Informal document **GRRF-78-43**  
78<sup>th</sup> GRRF, 16-19 September 2014  
Agenda item 9(b)

# Amendment proposals to UN R79 to introduce the requirements of Lane Keeping Assistance System

Presentation in conjunction with **GRRF-78-05**

## **4)ON/OFF means (selectable by the driver)**

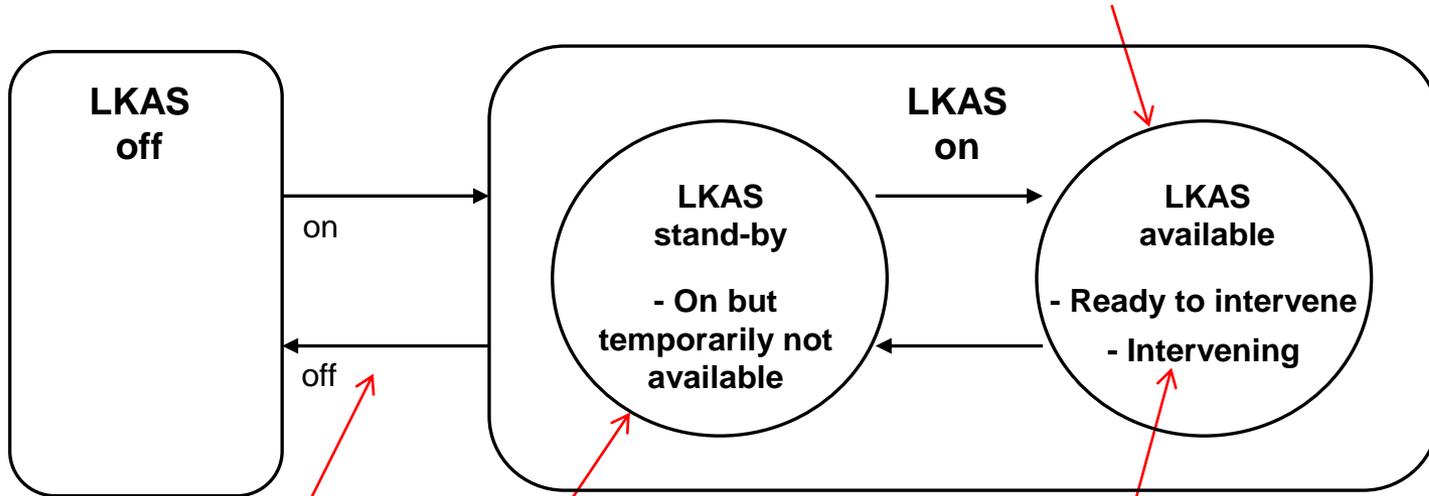
ON/OFF means is optional, but the requirement is prescribed for clarification.

- 5.1.6.4. The vehicle may be equipped with a means for the driver to activate or deactivate the Lane Keeping Assistance System.**
- 5.1.6.5. [The system shall have at least 1 type of means to detect driver attention e.g. by sensing the driver's hands on the steering wheel. When the system detects inattention of the driver, it shall give an effective warning [, which shall be at least two means out of optical, acoustic and appropriate haptic,] to call the driver's attention.]**
